New Science Building at Mulcahy Middle School
1001 W. Sonora Avenue
Tulare, CA 93274

TETER Project No.: A 19-11345 D

END OF ADDENDUM NO. 04

JOB NUMBER:
19-11345
 DWG. DATE:
1/13/2022
AD4-E01

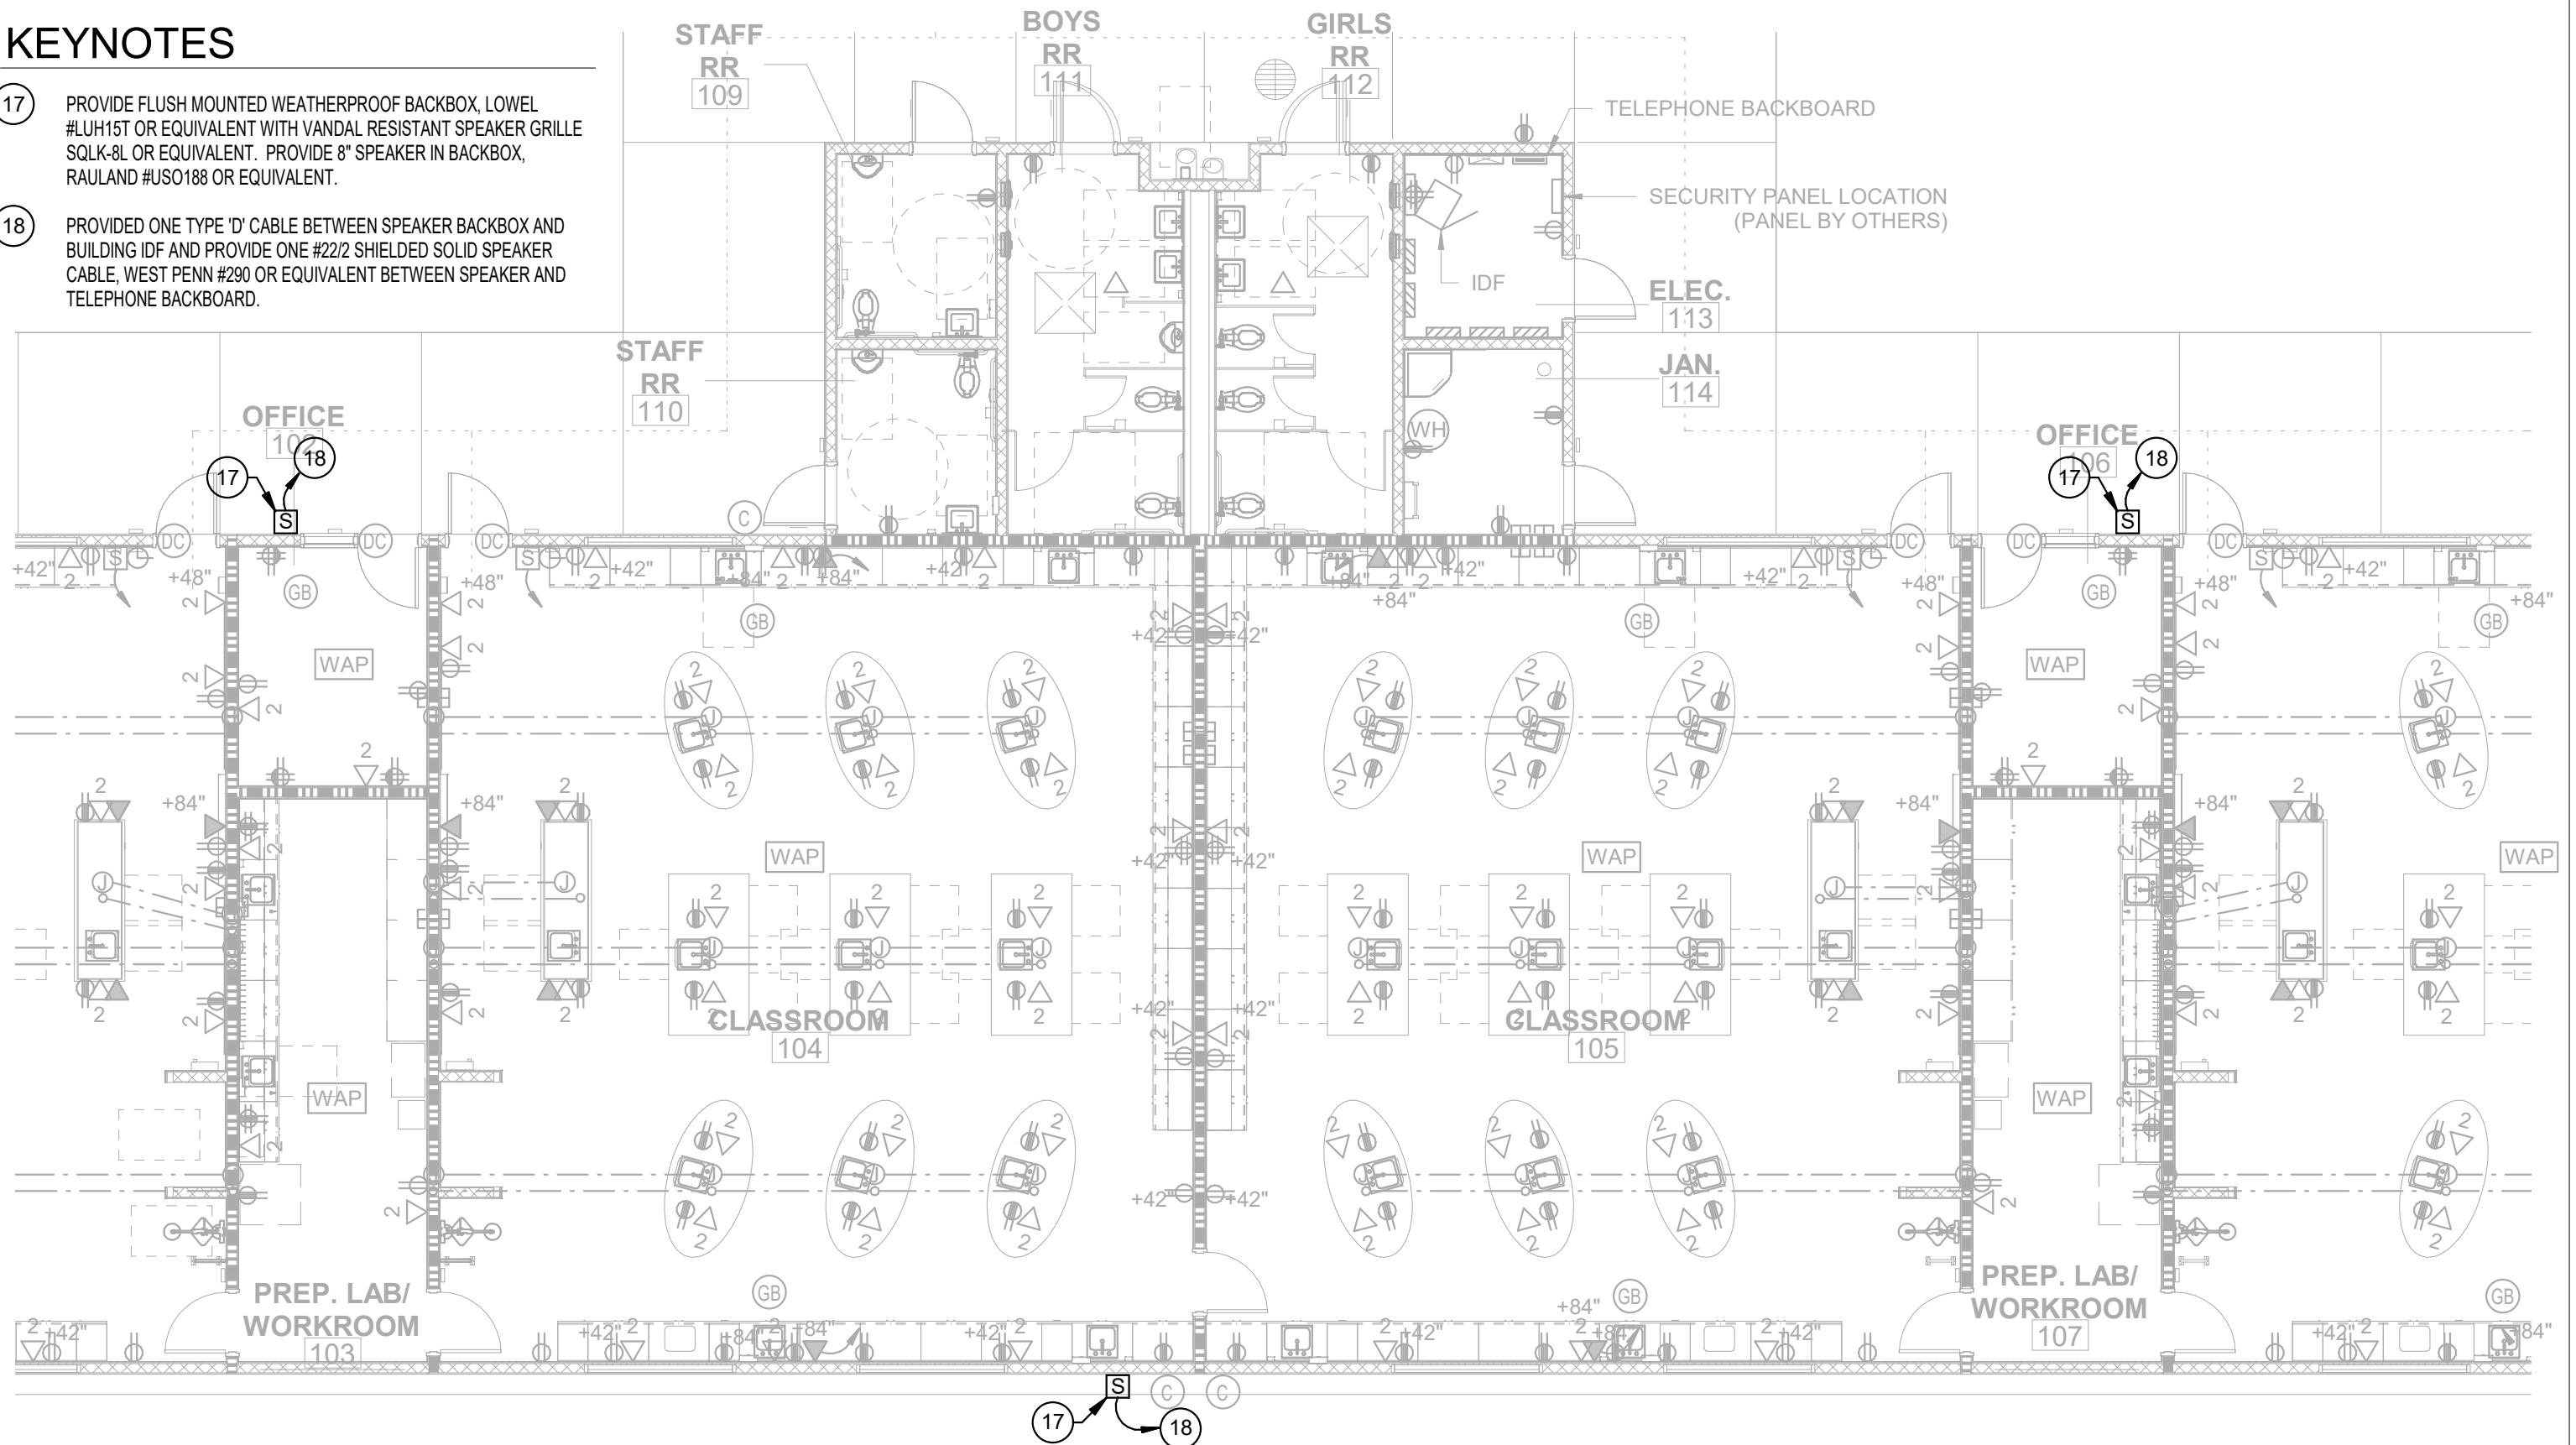
4 – 02: DRAWINGS, SHEET AD4-E01 – REVISED SIGNAL PLAN:

A. Provide three (3) outdoor speakers to E400 per drawing AD4-E01.

KEYNOTES

- 17 PROVIDE FLUSH MOUNTED WEATHERPROOF BACKBOX, LOWEL #LUH15T OR EQUIVALENT WITH VANDAL RESISTANT SPEAKER GRILLE SQLK-8L OR EQUIVALENT. PROVIDE 8" SPEAKER IN BACKBOX, RAULAND #USO188 OR EQUIVALENT.
- 18 PROVIDED ONE TYPE 'D' CABLE BETWEEN SPEAKER BACKBOX AND BUILDING IDF AND PROVIDE ONE #22/2 SHIELDED SOLID SPEAKER CABLE, WEST PENN #290 OR EQUIVALENT BETWEEN SPEAKER AND TELEPHONE BACKBOARD.

JOB NUMBER:
19-11345
 DWG. DATE:
1/13/2022
AD4-E02

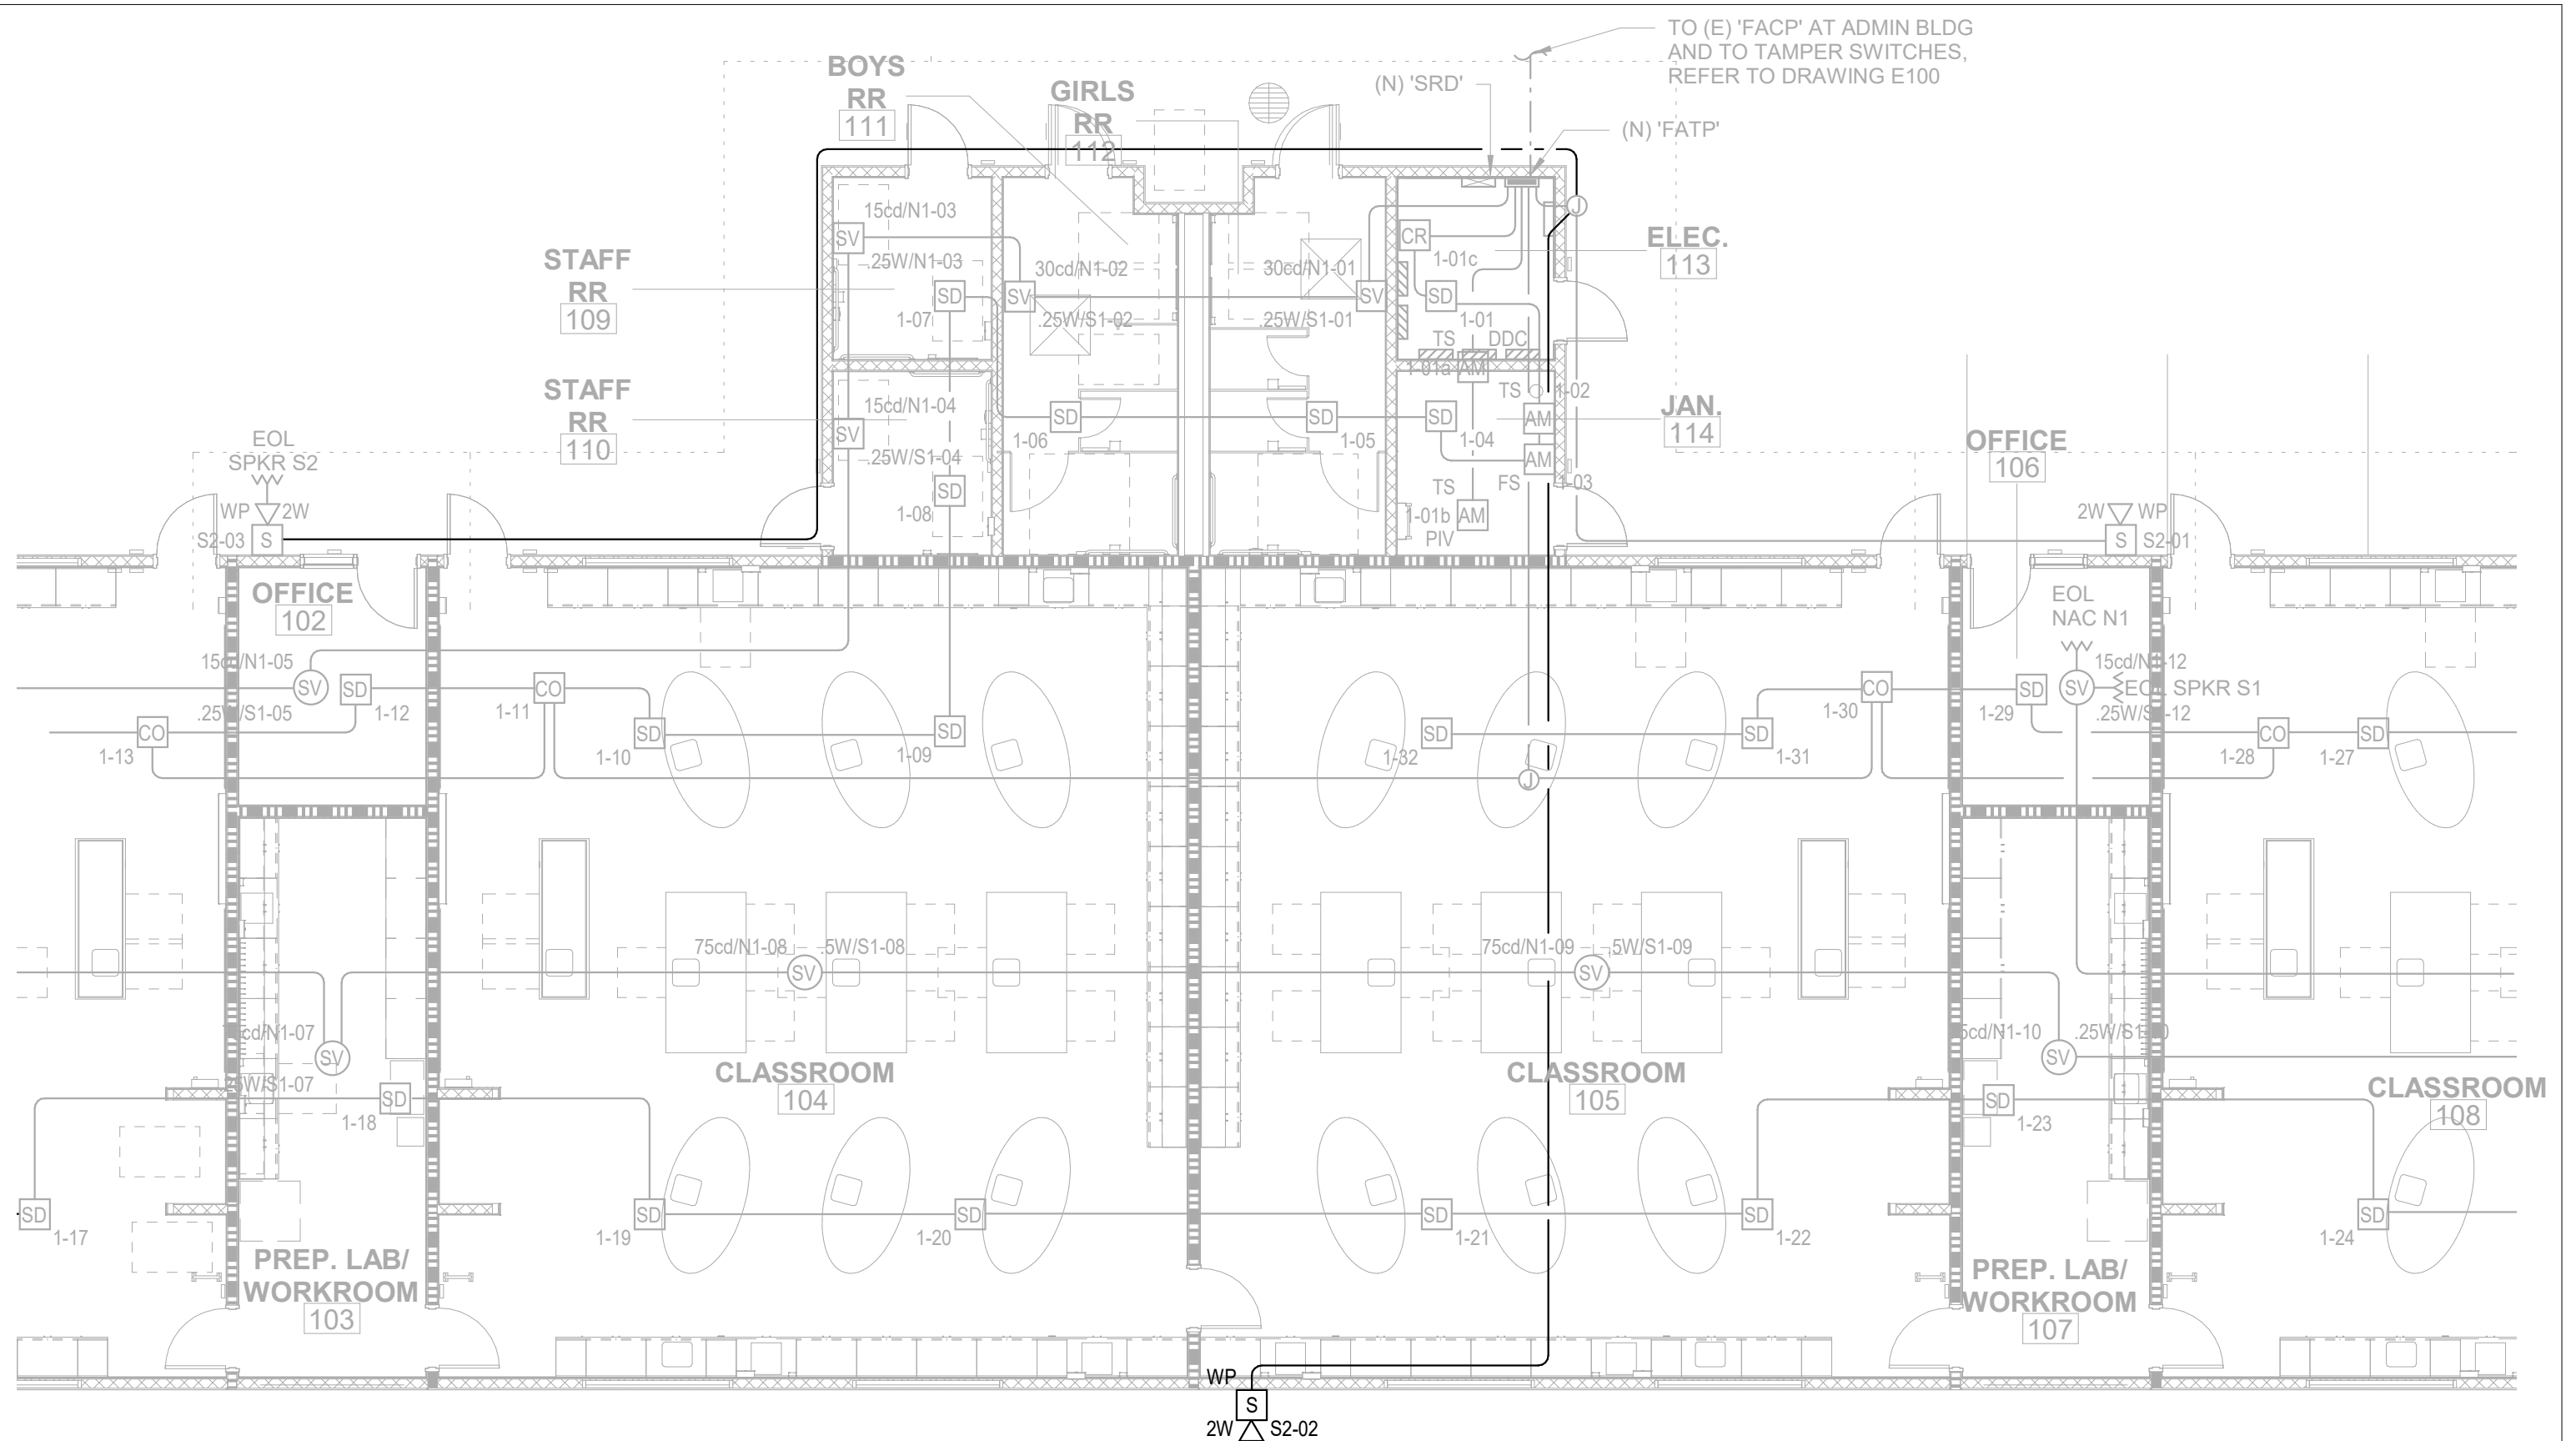
4 – 03: DRAWINGS, SHEET AD4-E02 – REVISED FIRE ALARM PLAN:

A. Relocate one (1) exterior fire alarm speaker to E500 per drawing AD4-E02.
